CITY OF ALBUQUERQUE

RE: 8300 Calle Nortena NW
Grading Plan
Stamp Date: 2/7/17
Hydrology File: C11D003

Based upon the information provided in your submittal received 3/7/2017, the Grading Plan **is not** approved for Building Permit. The following comments need to be addressed for approval of the above referenced project:

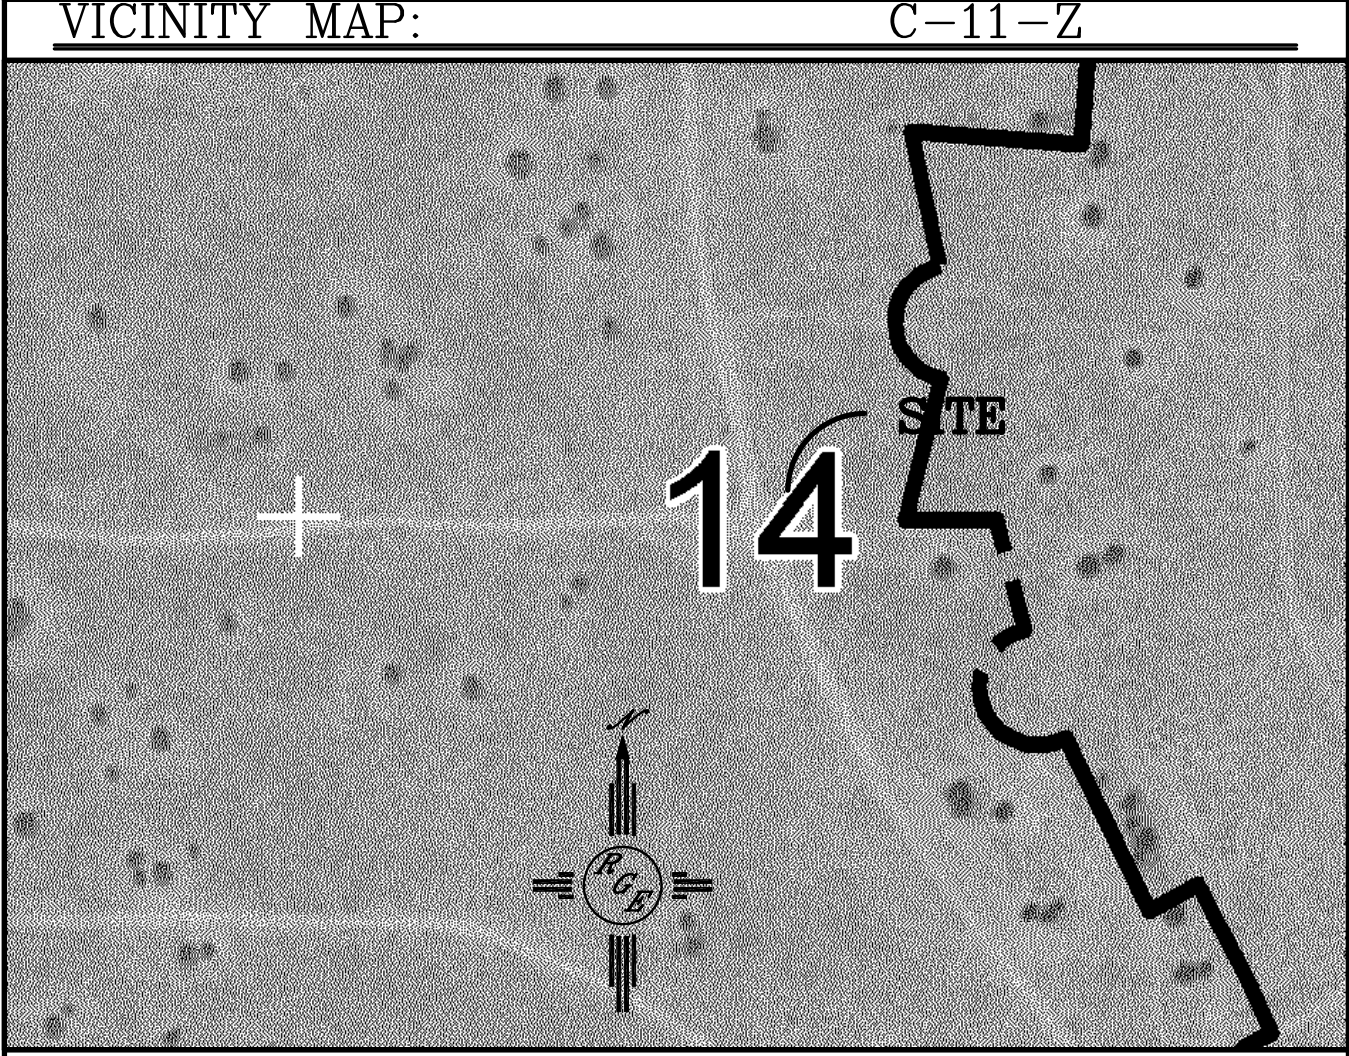
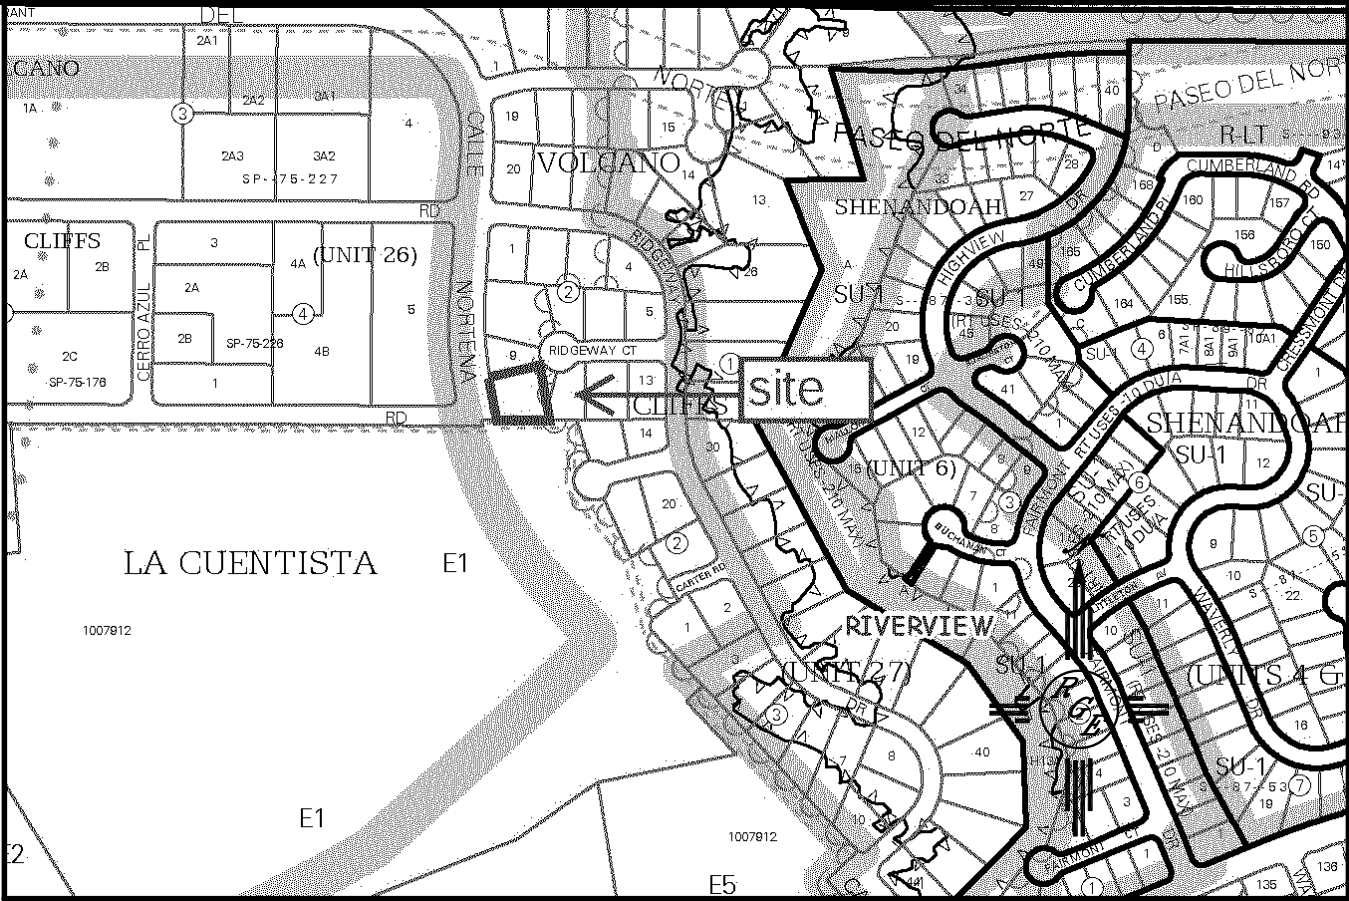
1. It appears that you calculated required volume for capturing the first ½ inch (detention) is low. It should be 0.02 ac-ft or 871 CF.
2. The proposed grading appears to actually separate the site into two separate drainage basins. The north half drains to the proposed pond. The south half drains to the southeast corner of the site. The south half of the site's drainage is not captured by a pond and just directly flows off site. You need to create a pond to capture the runoff.
